UNITED STATES PATENT AND TRADEMARK OFFICE

Office Action Summary	Application No. 10/566,284	Applicant(s) KIM, SU GEN	
	Examiner Fannie Kee	Art Unit 3679

DETAILED ACTION

FIG. 2

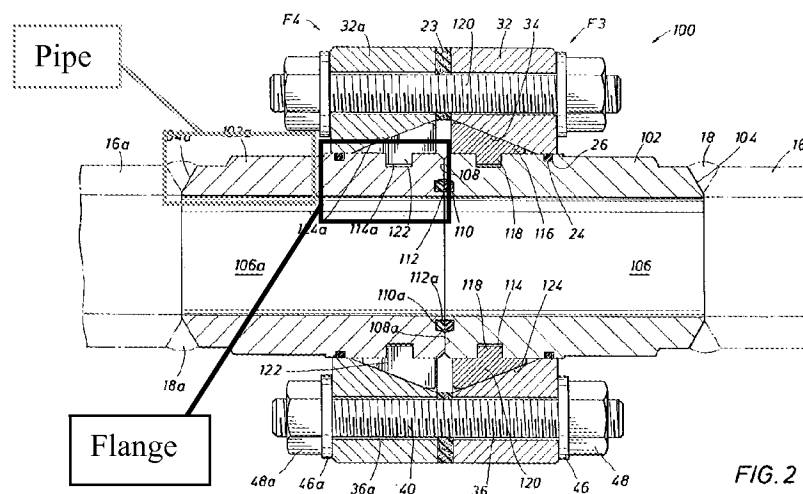
With regard to claim 1, and as seen in Figure 2 below, Baker discloses a pipe joint device, comprising:

flanges (102a, 102) mounted to ends of pipes to be coupled together or ends of both a pipe and a pipe joint to be coupled together, the flange having at least one ring groove (grooves at (114, 114a) around an outer circumferential surface thereof;

a packing (122, 120) mounted to the flanges and having inner rings protruding from and integrally formed around an inner circumferential surface of the packing to closely engage with the ring grooves of the flanges; and

a clamp (32a, 32) having a packing seat (34, 124a) to seat the packing therein, with a support sidewall formed by a radial inward extension of each side of the clamp, the clamp being divided into a plurality of clamp parts so that the clamp parts are placed around the packing and are fastened together by a locking member.

With regard to claim 6, and as seen in Figure 2, Baker discloses the flanges being stopped by the support sidewalls of the clamp (via the sealed connection between the support sidewalls and the seals 24 and 24a) so that the pipes or the pipe and the pipe joint are prevented from being removed from the clamp.
